Response to Anonymous Referee #1 Comments

Review of The CALIPSO version 4.5 stratospheric aerosol subtyping algorithm by Tackett et al.

Response to Anonymous Referee #2 Comments

Response to Anonymous Referee #3 Comments

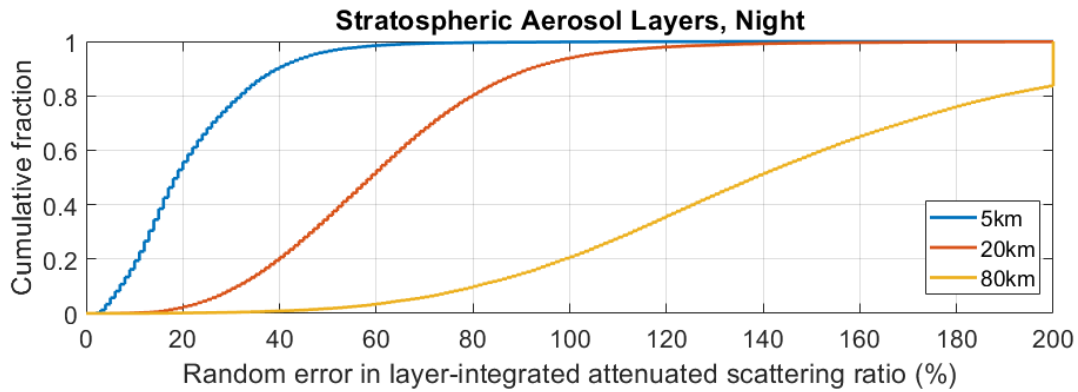
Second, I think there should probably be some emphasis on the idea that the errors in the estimated particulate depolarization ratio are dominated by systematic rather than random errors, and possibly some analysis or demonstration of why estimated particulate depolarization ratio is nevertheless necessary for classification or better than volume depolarization, which is more likely to be strongly dominated by random rather than systematic errors.

L179-180 includes the attenuated molecular backscatter, "calculated from the MERRA-2 model". How can the particulate attenuation of the molecular backscatter be calculated accurately given there is no measurement of the attenuation? Or is the particulate attenuation left out? I hope this will be made more explicit, including some comment about what errors or uncertainties are likely. It seems logical that if the particulate attenuation is not accounted for, then R' will have a systematic low bias (compared to true aerosol backscatter ratio), and estimated particulate depolarization would have a high bias. Is that correct?

That is correct – particulate attenuation is not accounted for within the layer. This information has been explicitly discussed in a dedicated paragraph in Sect. 3 with the new Fig. 3(a), shown below, that demonstrates the high bias that arises in the estimated particulate depolarization ratio.

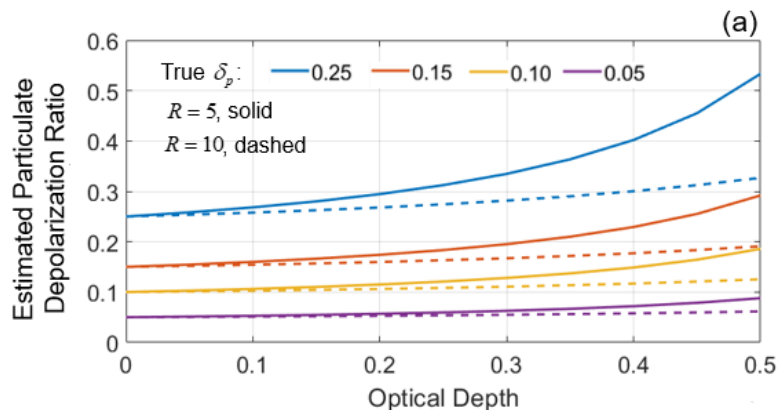
L58 mentions the algorithmic motivation for getting the right aerosol type is the need to correct the overlying attenuation. How sensitive are the retrievals lower in the atmosphere to having the correct type in the stratosphere? That is, I realize there is a one-to-one relationship between error in layer lidar ratio and the error in the AOT for the same layer, but can the authors describe how much the uncertainty for lower layers is increased given the distribution of stratosphere layer optical thickness? This would address not just correct typing, but also how much impact changing the volcanic ash lidar ratio would be expected to have.

We chose to add this information to Sect. 4.5 which discusses lidar ratios to avoid bogging the introduction down in too many details. Here is the new paragraph that now starts off Sect. 4.5:

“As emphasized in the introduction, the algorithmic motivation for improving aerosol subtyping is to ensure that a representative lidar ratio is selected for that subtype, thereby yielding accurate extinction retrievals. Because CALIOP retrievals operate from top-down, any errors in the retrieved extinction due to incorrect lidar ratio selection will propagate into underlying layers. The previous subsections described the improvements we made to increase the likelihood that the correct stratospheric aerosol subtype (i.e., correct lidar ratio) will be selected. However, it is also important that the lidar ratio for these subtypes are representative of what is observed in nature. A full, detailed accounting of error propagation in CALIOP extinction retrievals is given in Young et al., 2013, including the impacts of incorrect lidar ratio selection. One key take-away from that paper is that the relative error in retrieved AOD equals the relative error in the lidar ratio for layers having low optical depths, typical of aerosol. A second key take-away is that the error in retrieved

AOD due to incorrect lidar ratio selection behaves as a systematic bias in the retrieval of optical depth for underlying layers. The magnitude of the error in AOD for the underlying layer depends on its R' , AOD, and the magnitude of the error in lidar ratio of the overlying layer. In general, though, the sign of the AOD bias is the same as the sign of the error in lidar ratio selection of the overlying layer (i.e., selecting too low of a lidar ratio causes an underestimate in AOD of layers at lower altitudes). Feature detection accuracy for lower layers can also be degraded if overlying attenuation is not correctly accounted for. Clearly, accurate lidar ratio selection is critical for elastic backscatter lidar retrievals.”

Figure 6. Same joint distributions as Fig. 4, but for layers classified as PSA in the southern hemisphere in 2013, based on V4.5 data.

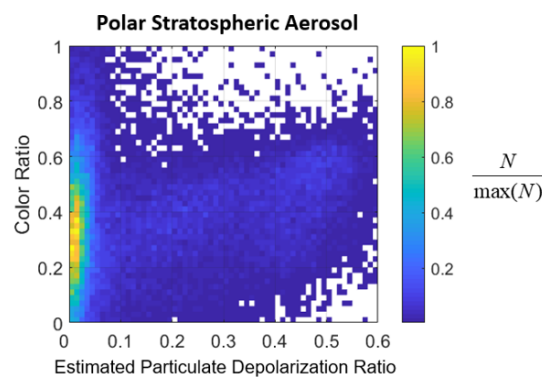
Figure 3. I'm curious to see a panel which shows a representative selection of known PSA, which would help illustrate why the PSA selection must be done before thresholding on depolarization.

This suggestion was very helpful. We added the figure below to this section which showed quite a broad range in depolarization values. With this as a basis, we modified our rationale in the text to, "These layers are often detected adjacent to features classified as cloud and have depolarization levels that overlap with the expected ranges for sulfate, smoke, and ash (Fig. 6)... The PSA classification prevents these layers from being misclassified as volcanic ash or sulfate when none exists."

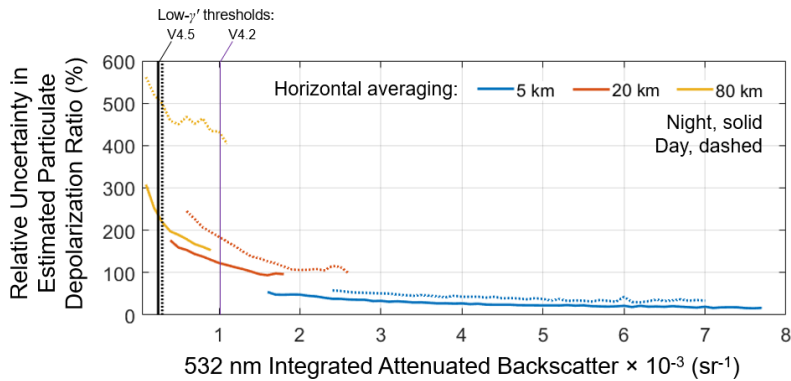
L365-366 "The lowest quartile... was selected so that the average relative uncertainty in estimated particulate depolarization is less than 250%" (and following text). While I'm not surprised by very large uncertainties in estimated particulate depolarization ratio for small signal levels, it's not immediately obvious how an uncertainty of more than 100% is particularly useful, and whether it should make any practical difference if the uncertainty is 200% or 400%, especially given that sulfate has essentially zero depolarization and therefore always has a large relative uncertainty. However, the uncertainty in the estimated particulate depolarization is strongly dominated by systematic, rather than random, uncertainty, particularly for small values of the attenuated scattering ratio, due to the mathematical form of Eqn 2 (see, e.g. Burton et al. 2015) which is a strong and valid reason for wanting to cut off this calculation at values before the systematic error blows up. I think the discussion would be clearer and more informative if the discussion explicitly refers to this systematic uncertainty from Eqn 2 and perhaps includes a figure showing how the resulting uncertainty depends on the attenuated backscatter.

Indeed, a visualization would help make the message clearer and add more information. To acknowledge the rapid increase in uncertainty for low IAB values, we added these sentences,

“At low signal levels, δ_p^{est} becomes prone to increases in systematic and random errors along with the increased risk of overestimates as discussed in Sect. 3....The lowest-quartile γ'_{532} metric was selected based on the rapid increase in relative uncertainty in δ_p^{est} as a function of decreasing γ'_{532} (Fig. 12).”

Here is the new Fig. 12 which shows the old and new thresholds and how they relate to the relative uncertainty in δ_p^{est} . Adding this figure adds valuable information, that the average relative uncertainty for stratospheric aerosol layers detected at 5 km resolution is less than 50%. A sentence is added to the section to note this.

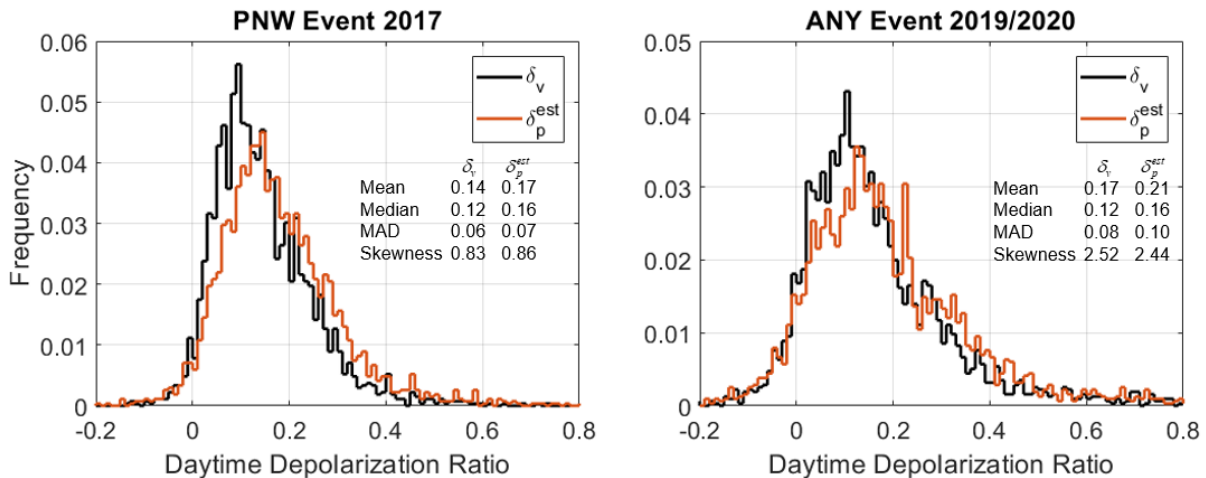
L618-619 "This reflected sunlight enhances noise throughout the profile overhead, thereby increasing the variability of depolarization ratio measurements". It's clear that noise would increase the variability of the depolarization measurements, including volume depolarization, but why does it produce an asymmetric tail with more large values? Is this because the negative branch is cut off (I mean if negative depolarizations were reported and graphed would there be a symmetric tail on that side?) or is it related to the propagation of error from the volume depolarization to the estimated particulate depolarization? By which I mean, if the volume depolarization distributions are plotted, are they wider during the day but still symmetric? If so, then, considering that noise also increases the variability in R' , perhaps the issue is again the R' errors propagating non-linearly through Eqn 2, so that a symmetric distribution of error in R' (plus a symmetric distribution of volume depolarization) becomes an asymmetric distribution of particulate depolarization.

The asymmetric tail in the daytime depolarization is inherent to the volume depolarization ratio. The figures below compare the volume and estimated particulate depolarization ratios for the two events in Fig. 21 (previously Fig. 18 in the initial submission). The statistics on the charts show

that the breadth and skewness did not change appreciably or at least enough to confidently attribute the asymmetric tail to amplification of systematic errors in R' through Eqn. (2). However, we agree that the negative depolarization should be shown to clearly represent the distributions. For this, we reduced the lower limit of depolarization on the x-axis of Fig. 21 so that the negative depolarizations are shown.

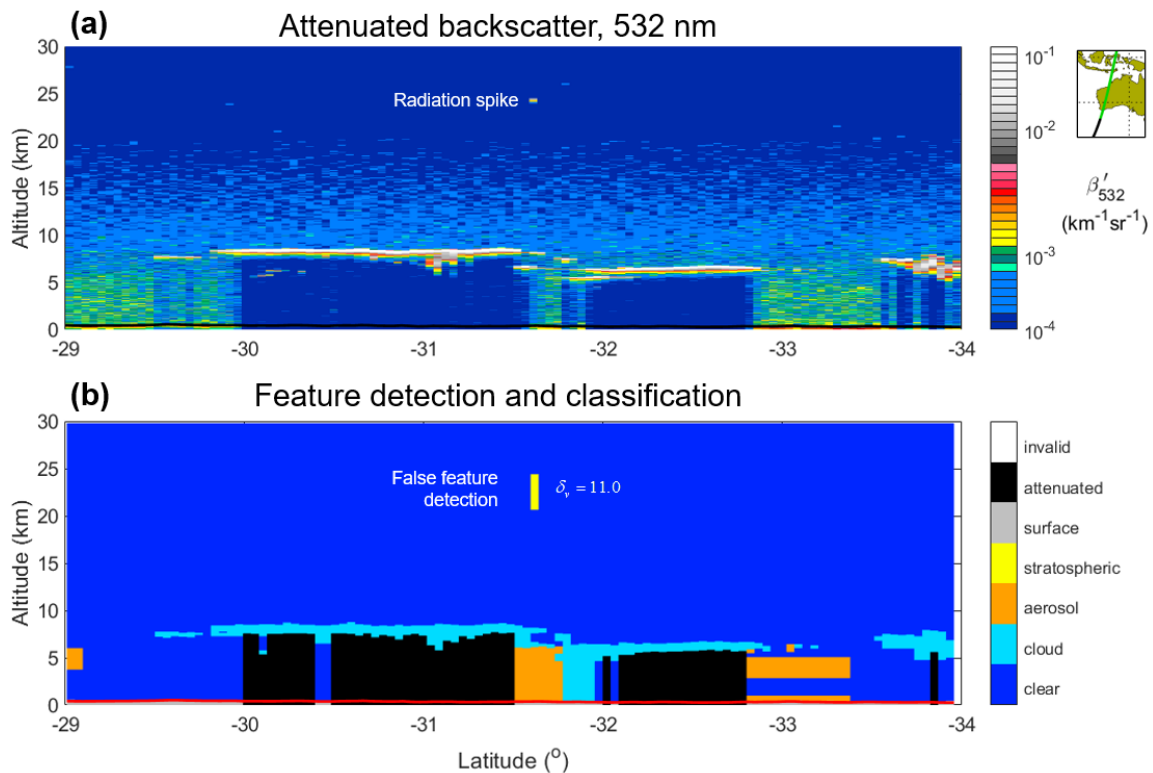
L656 "The aerosol subtypes of these false layer detections" I'm confused whether these percentages refer to the whole population of false layer detections, or only to the subgroup that remains after filtering for the SAA and low CAD scores. If they include the low CAD group, then is it likely that the dominance of high-depolarization aerosol types might reflect mistyped cloud? Does the percentage classified as ash remain so remarkably high after the low CAD cases are taken out? If so, why should these non-layers be dominated by large depolarizations?

The following figures have been added to the supplement to show representative examples of false feature detections in CALIOP data. The first example Fig. S6 is a false detection due to a radiation-induced current spike in the 532 nm channel detector(s) (Hunt et al., 2009). Because the volume depolarization is so high for this layer, it is likely that the perpendicular channel was affected by the current spike and not the parallel channel. The second example Fig. S7 is daytime over the South Atlantic Anomaly region where excess radiation more commonly affects the CALIOP

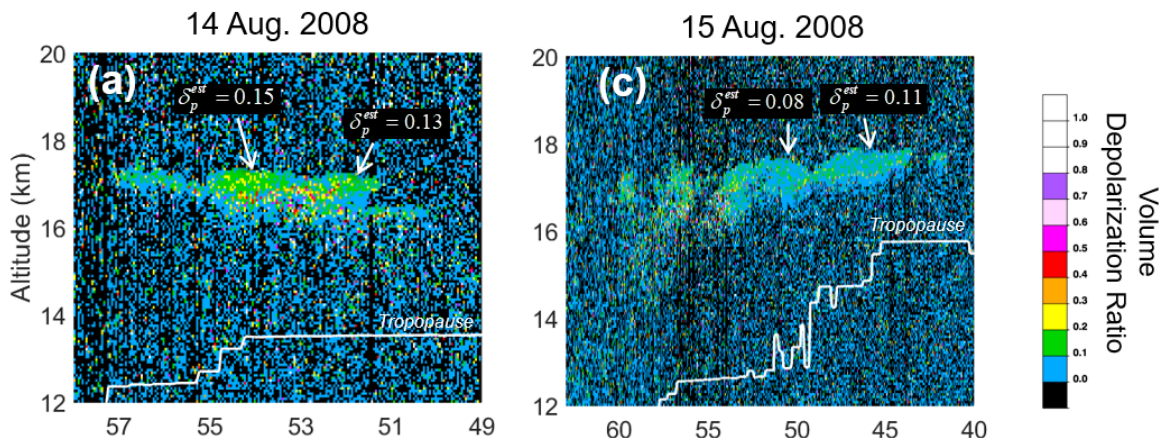
Figure 16. It's somewhat confusing that this shows volume depolarization ratio when the text primarily discusses estimated particulate depolarization ratio.

We prefer to show the volume depolarization ratio because it shows the range-resolved structure of depolarization. The estimated particulate depolarization ratio is only computed based on layer-averaged quantities in CALIOP processing, so the variability in depolarization would not be as obvious if estimated particulate depolarization ratio were plotted. In order to better give the sense of its value, call-outs were added to each figure giving representative values of estimated particulate depolarization for different parts of each plume.
